Conventional Onsite Sewage Disposal System Design Plan Requirements

RE: OSDS Plan Review
10380 Cavey Lane
Woodstock, MD
Map 11, Parcel 39

Onsite Sewage Disposal System Design Plan

KANE PROPERTY
 10380 CAVEY LANE WOODSTOCK
 HOWARD COUNTY, MARYLAND 21163

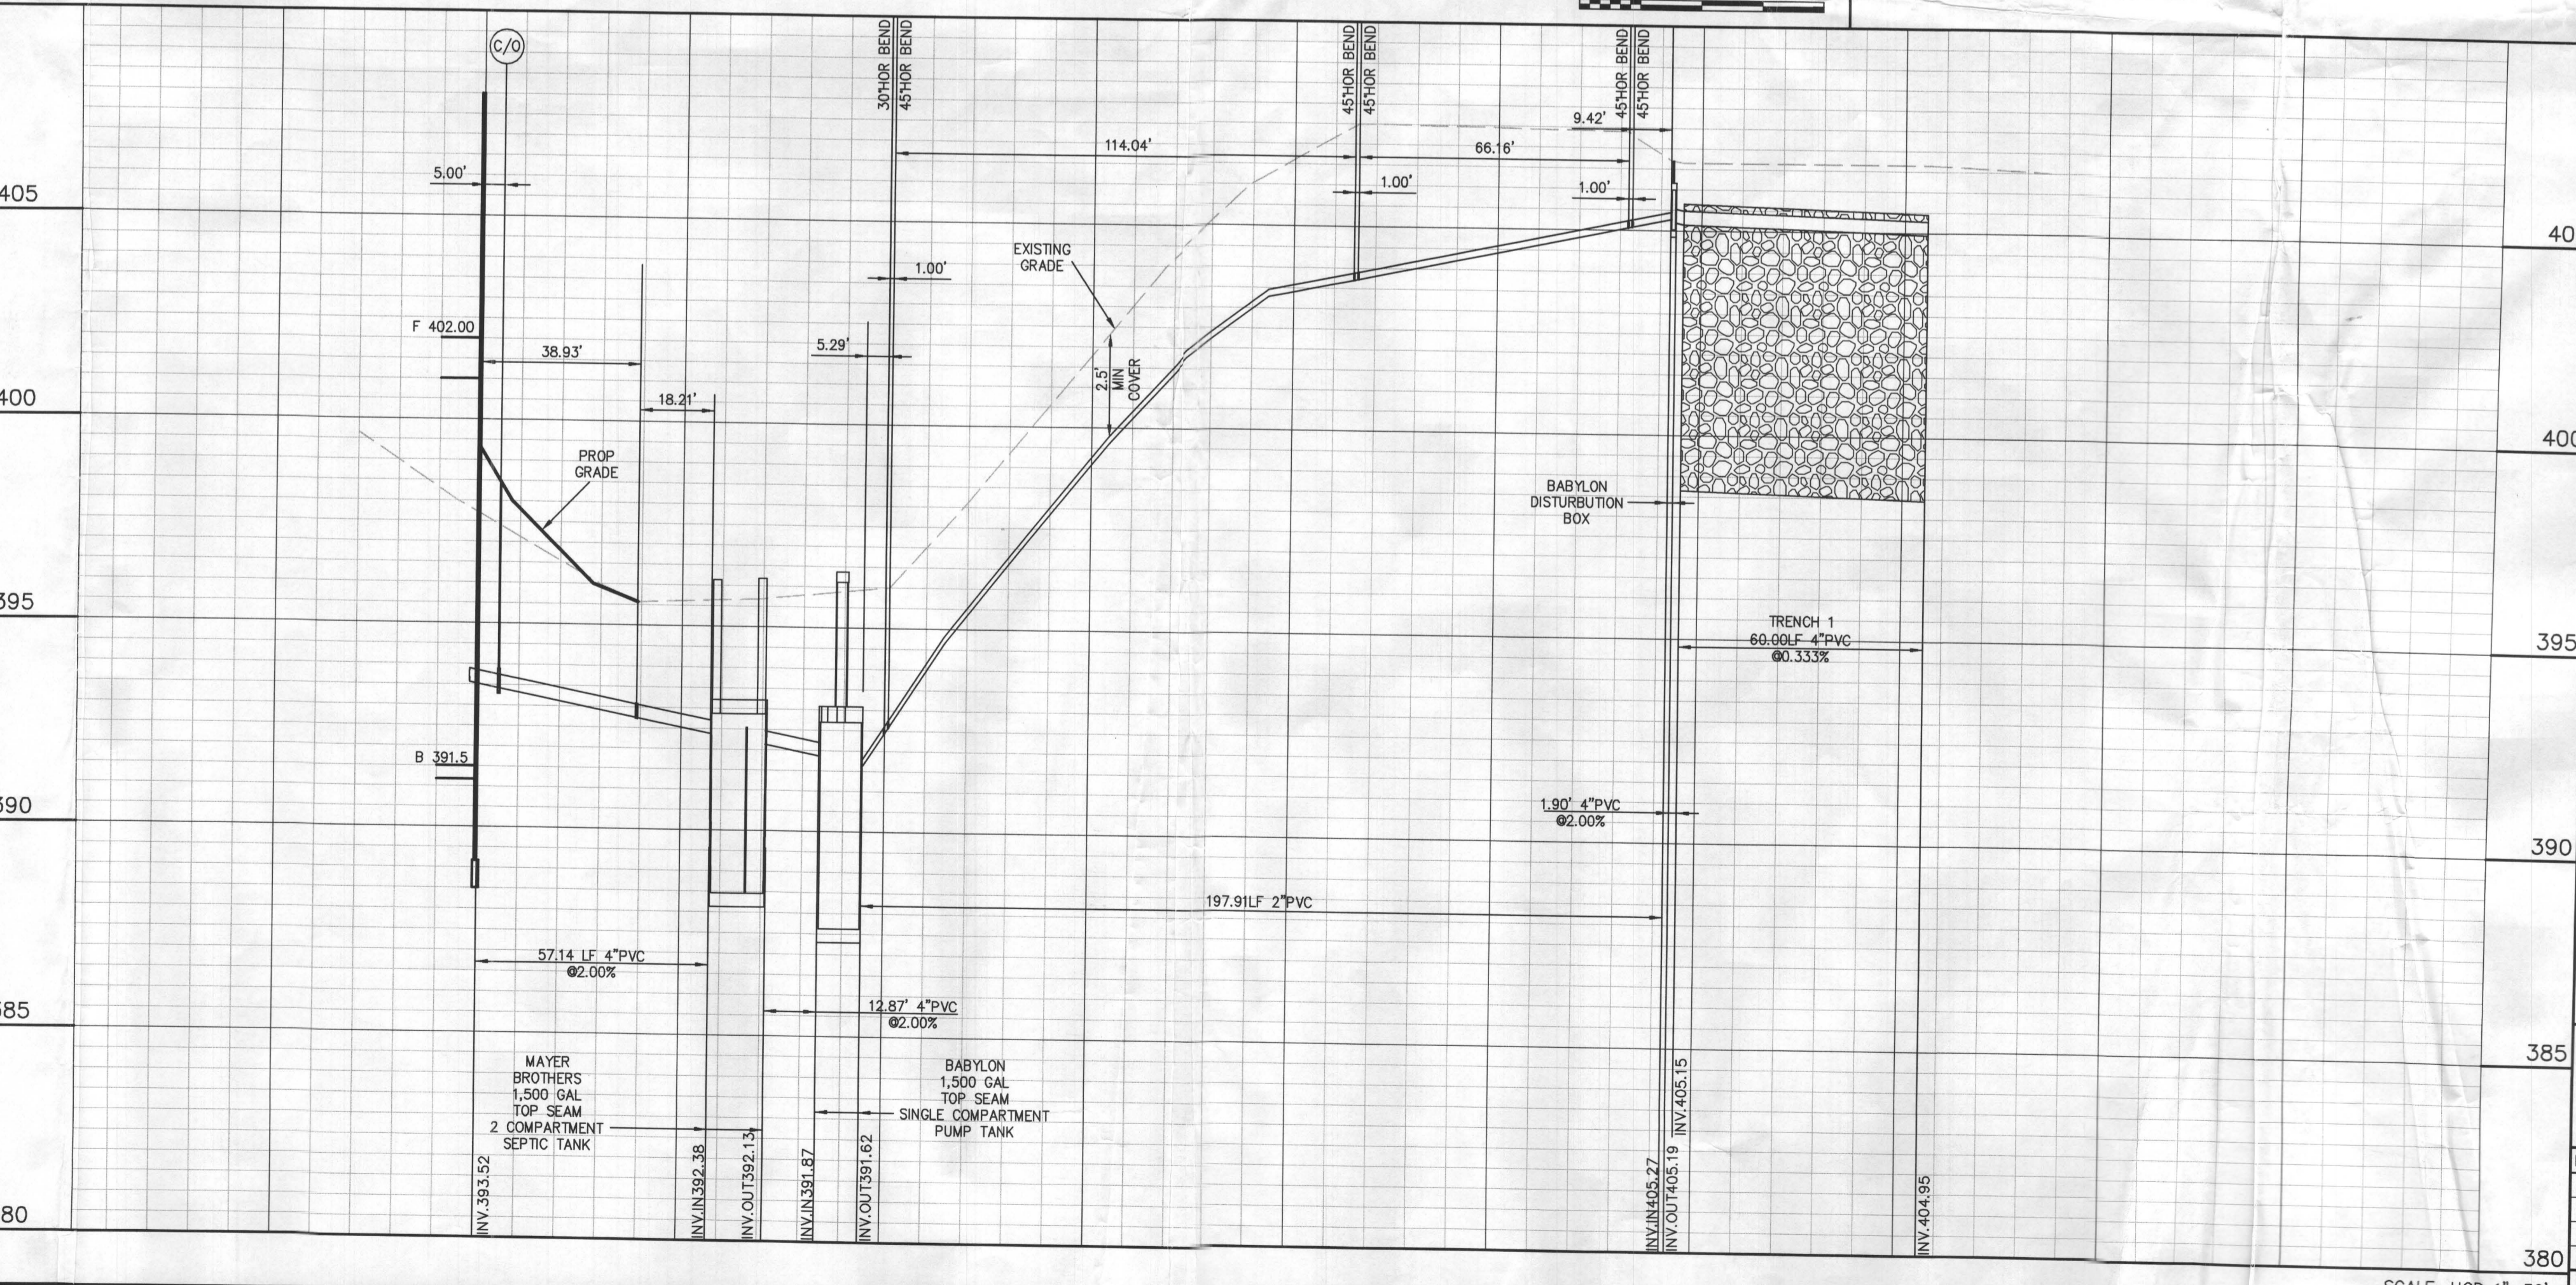
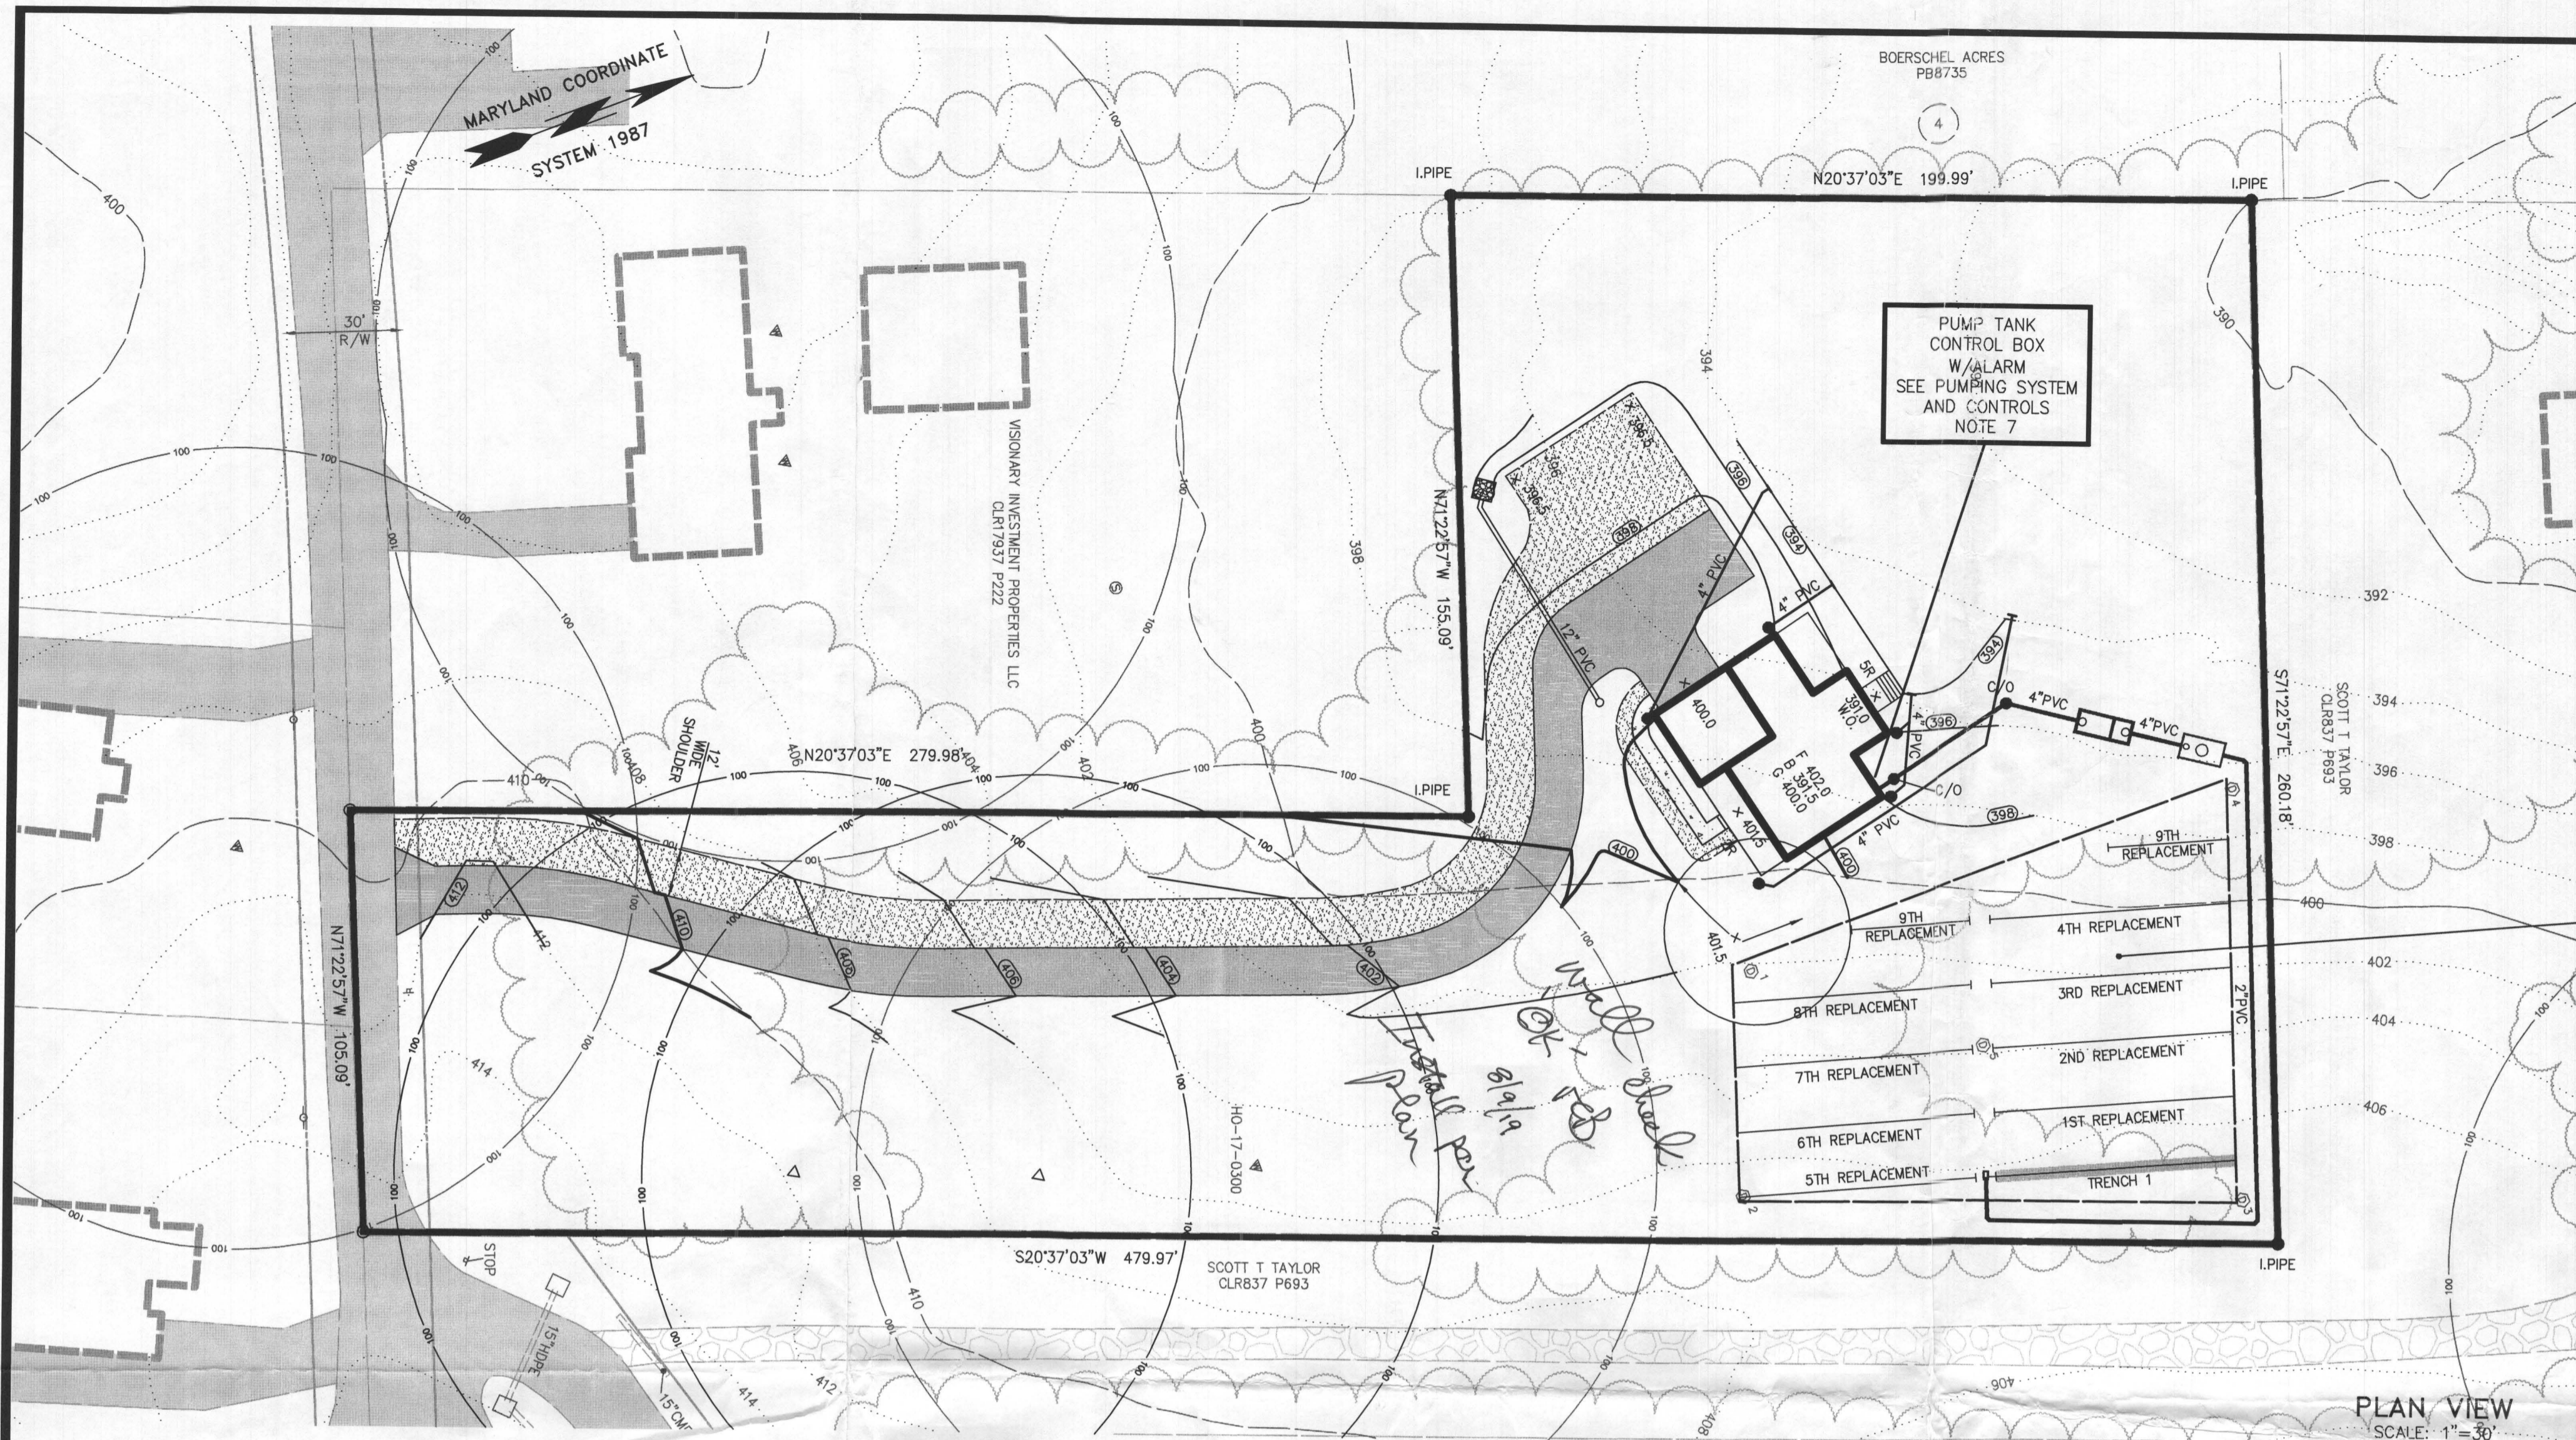
- 1.) Swale is within 50 feet of the well sites.
- 2.) Swale is within 25 feet of the Sewage Disposal Area
- 3.) Tanks are within direct path of swale.
- 4.) Add additional elevation labels to plan.

2 revisions moving forward: The 4 in. pvc storm water pipe must be extended 25 feet from the tanks. In addition, the trenches must be shown on contour. I could probably redline the plan but I would prefer revised copies of the first page.

- 1.) Well sites may not be within 50 feet of the swale along driveway.
- 2.) Dose Volume is just 1/6 design flow or 100 gallons in this case.
- 3.) At TDH of 17.306, the line intersects the curve at 35 GPM. The pump run time should be 3 minutes to achieve dose volume.
- 4.) In keeping with proper system design, raise trench inverts to a minimum depth of 18 inches.

- 1.) Swale is within 50 feet of the well sites.
- 2.) Swale is within 25 feet of the Sewage Disposal Area
- 3.) Tanks are within direct path of swale.
- 4.) Add additional elevation labels to plan.

In our telephone conversation on 2019-03-21 you stated you wanted the invert of the pipe to be at a minimum depth of 18 inches which will leave only 12 inches of cover. I would ask what you would require of this was a typical standard trench with MDE standard depth of 1 foot of stone from 2-3 feet and the pipe invert at 2.5 feet. We do not have a lot of experience working in Howard County, however this seems in conflict with standards used in recent projects, below is some recent projects in the county. We have revised the plans per your request, 12 inches minimum depth of coverage and 18 inches minimum depth of pipe invert.

After examination of COMAR and Howard County Code, I cannot find any reference to a restriction or setback to a swale. The proposed swale along the driveway is required to divert stormwater runoff from an ESD treatment and shifting to the west would require clearing on forest resources. The depth of flow in the swale of a 10 year event closest to the existing well is less than 0.48 feet at 2.08 feet per second which doesn't include any onsite impervious surface runoff.

The house has been moved and the runoff diverted to the south side of the house. There is a high point near the east side of the house and grading supports sheet flow around the north side of the house.

Swale being moved has invalidated this comment.

As directed, we have revised the plan with additional contour tags and spot elevations.
